ADDENDUM 3 - EXAM ROOMS 1 (R02) AND 2 (R03) CLARIFICATIONS AND CHANGE

Westside Health Care District
100 E. North Street
Taft, CA. 93268

1 - PARTIAL PLUMBING PLAN
ROOM 2 & 3 - EXAM ROOMS

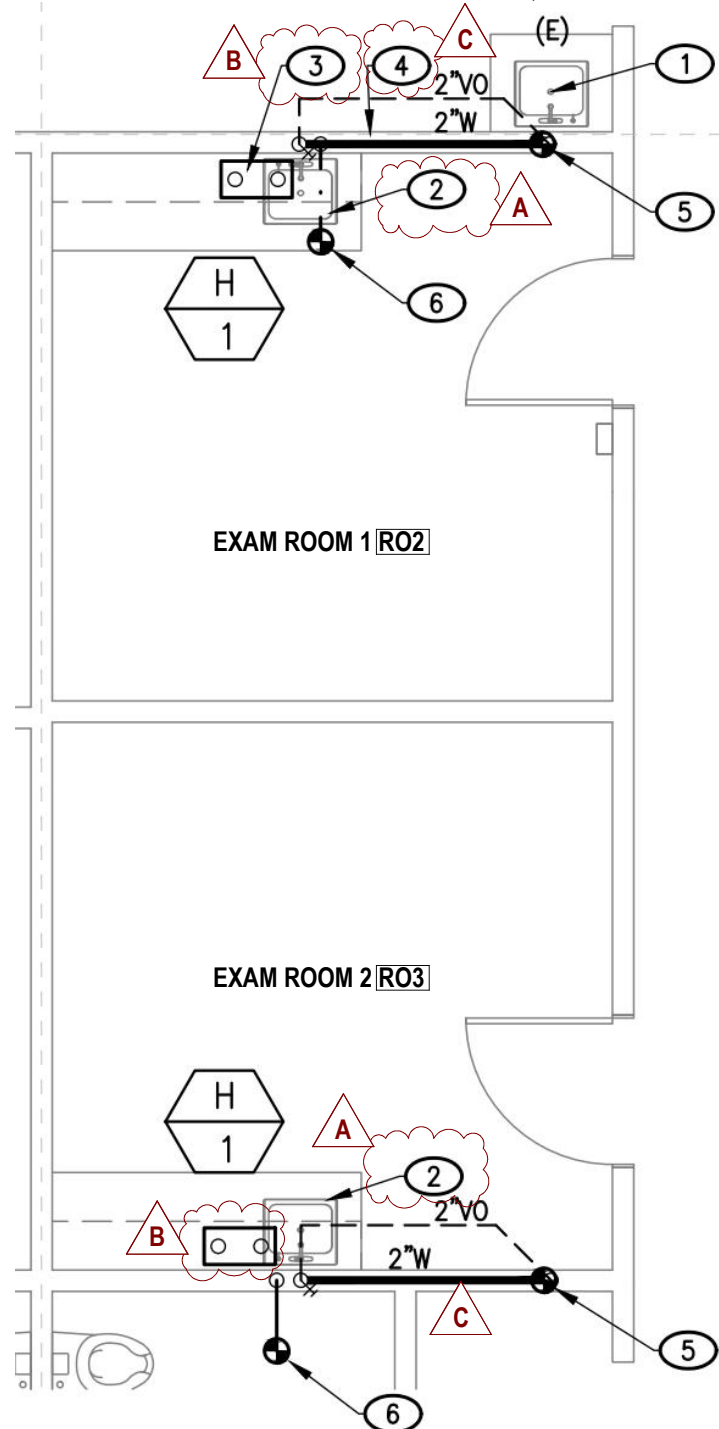
CLARIFICATION: SINK AND FAUCET SPECIFICATIONS
(KEYNOTE ② SHEET P3.0)

COUNTERTOP WITH INTEGRAL SINK FURNISHED UNDER THE SOLID COUNTERTOP SPECIFICATION SECTION. JUST J35FS FLAT GRID STRAINER. CHICAGO "HYDRONIC" "ECAST" #116.303.AB.1 SINGLE HOLE (OR T&S BRASS OR ZURN EQUAL). DUAL BEAM SENSOR OPERATED, 120V/1Ø ELECTRIC POWERED FAUCET WITH 12 VOLT A.C. TRANSFORMER. 5-1/4" RIGID/SWING GOOSENECK SPOUT WITH 1.5 GPM LAMINAR FLOW NON-AERATING OUTLET. LEONARD #170A-LF, POINT OF USE THERMOSTATIC MIXING VALVE.

CHANGE: WATER HEATERS REMOVED
(KEYNOTE ③ SHEET P3.0)

The electric water heater originally shown serving Exam Rooms 2 and 3 shall be removed from the project scope. All associated electrical and plumbing connections shown in the construction documents related solely to this water heater are to be omitted. Any necessary re-routing of affected services shall be coordinated in the field and submitted for review if required.

CLARIFICATION: KEY NOTE CORRECTION
(KEYNOTE ④ SHEET P3.0)

Keynote 4 should read:
"Expose all utilities *in wall* behind existing sink"
This applies to both the North and South Exam Rooms.
